## ADDENDUM #1

Reference: Stores & Receiving Building Expansion/Remodel Phase 2  
Weber State University

DFCM Project #: 05276810

### Addendum No. 01

# ROOF LADDER DETAIL

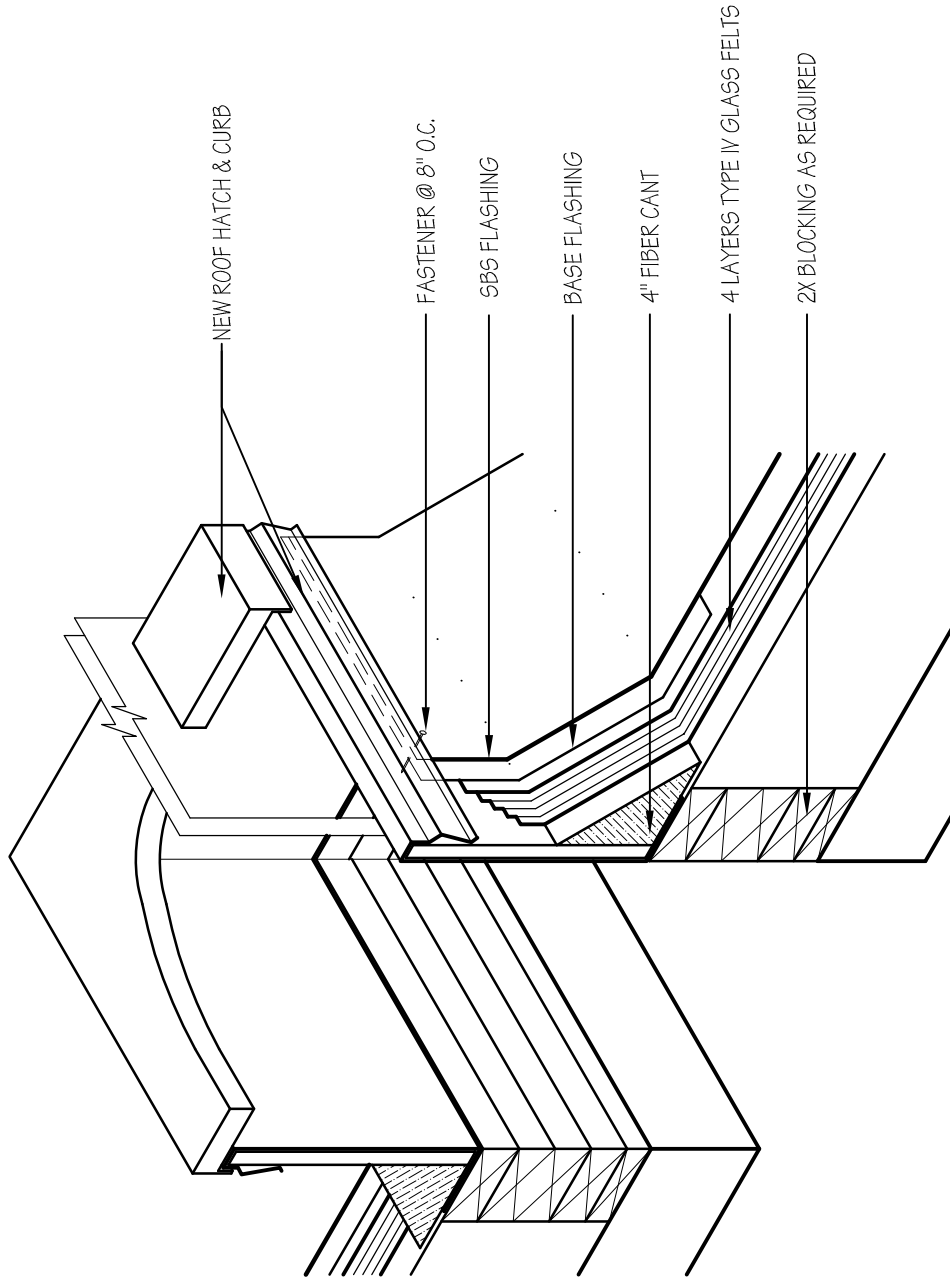
| 1 -8 | Details | Add the attached details: Roof Ladder Detail, Roof Hatch Detail, Mechanical<br>Curb Detail, EIFS Infill/Window Detail, Structural Detail S1, Structural Detail S2,<br>Structural Detail S3, Structural Detail S4.  |

SI

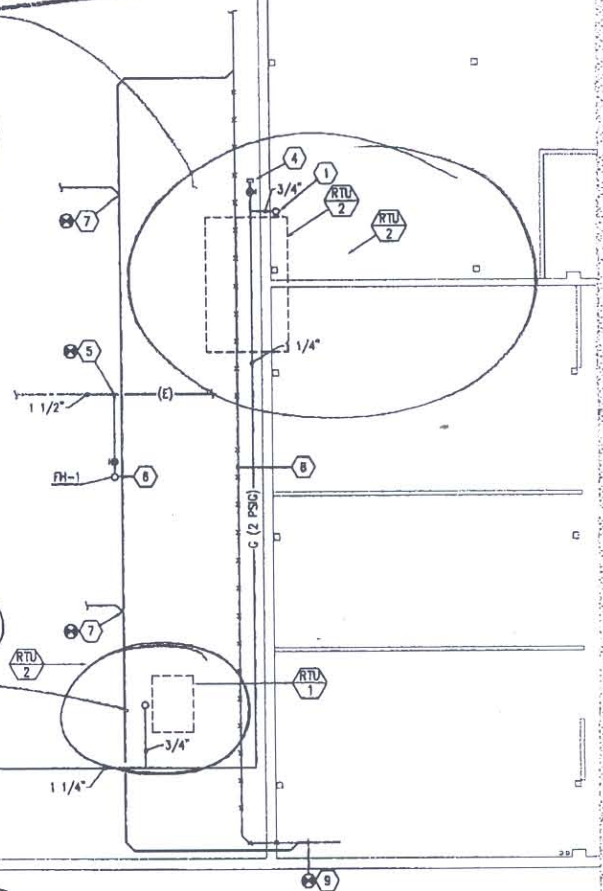
This Unit will not work.  
Roof is Good for only 36 psf  
Total Load

Move or provide independent  
Unit Support similar to  
Larger Unit

**S2**

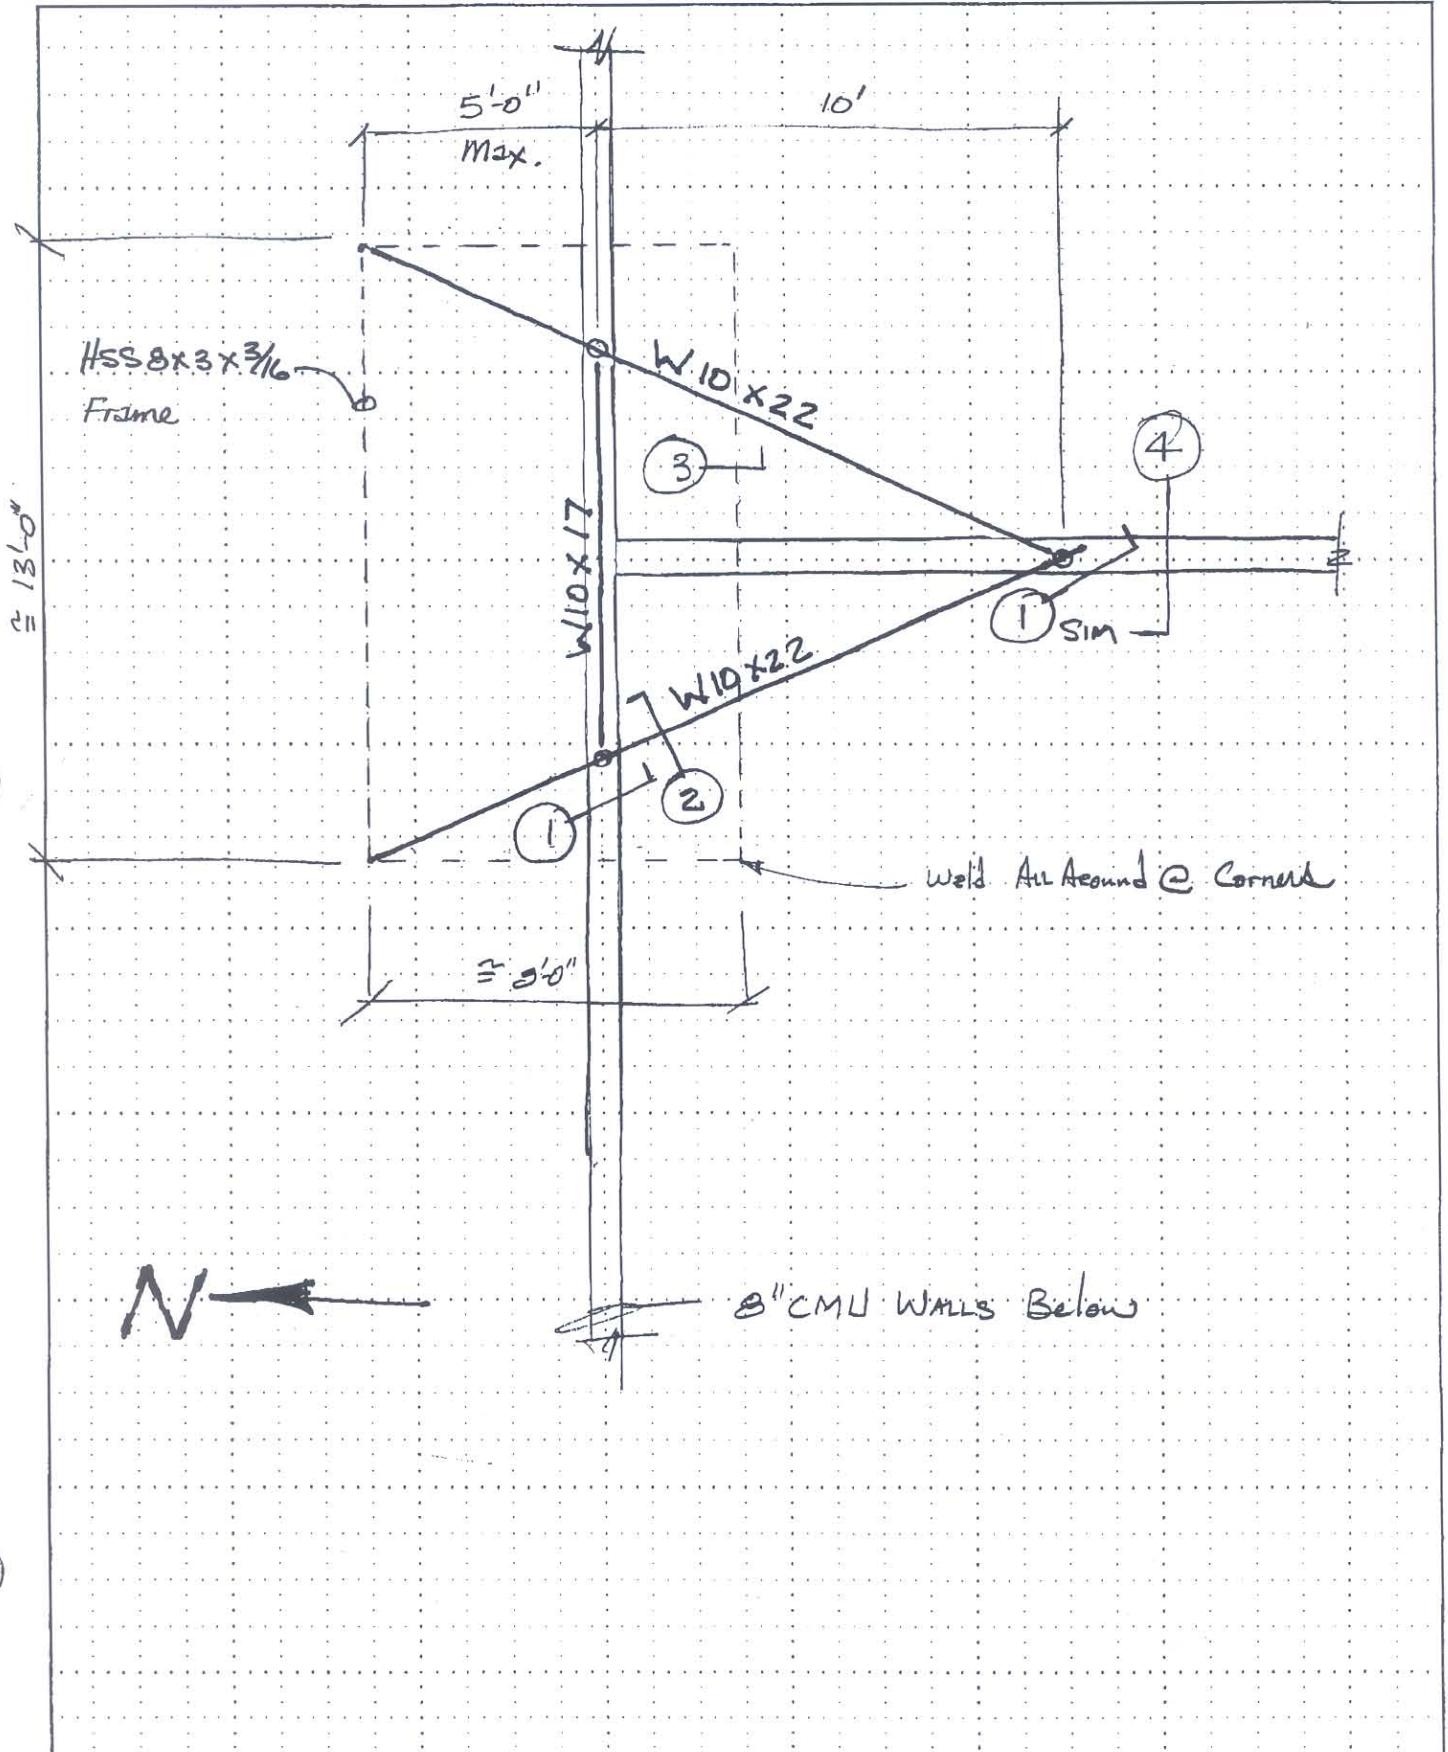
| 1 -7 | MH102   | Locate rooftop unit RTU-1 west of the wall between the warehouse and Printing<br>Services. Provide a side discharge roof curb similar to section A/MH102.<br>Extend the supply and return air ductwork above the roof to the roof penetration<br>locations shown. Coordinate the exact location of the unit with the Architect<br>and Structural Engineer. |
